Groundwater Application Review Summary Form

WATER RESOURCES DEPARTMENT June 28 ,20 18 **MEMO** Application G- 18606 TO: GW: Aron Boucher (Reviewer's Name) FROM: **SUBJECT: Scenic Waterway Interference Evaluation** YES The source of appropriation is within or above a Scenic Waterway X NO YES Use the Scenic Waterway condition (Condition 7J) NO X Per ORS 390.835, the Groundwater Section is able to calculate ground water interference with surface water that contributes to a Scenic Waterway. The calculated interference is distributed below. Per ORS 390.835, the Groundwater Section is unable to calculate ground water interference with surface water that contributes to a scenic waterway; therefore, the Department is unable to find that there is a preponderance of evidence that the proposed use will measurably reduce the surface water flows necessary to maintain the free-flowing character of a scenic waterway. DISTRIBUTION OF INTERFERENCE Calculate the percentage of consumptive use by month and fill in the table below. If interference cannot be calculated, per criteria in 390.835, do not fill in the table but check the "unable" option above, thus

Application G-18606

Water-Level Trends in Nearby Wells

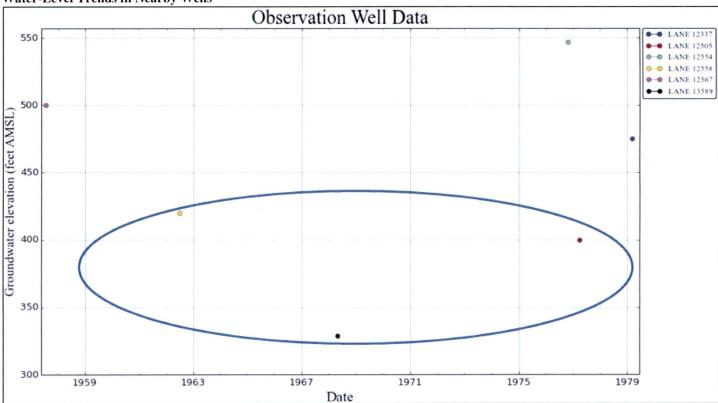
At the location of the proposed well it is likely that the groundwater elevation will fall within the range circled.
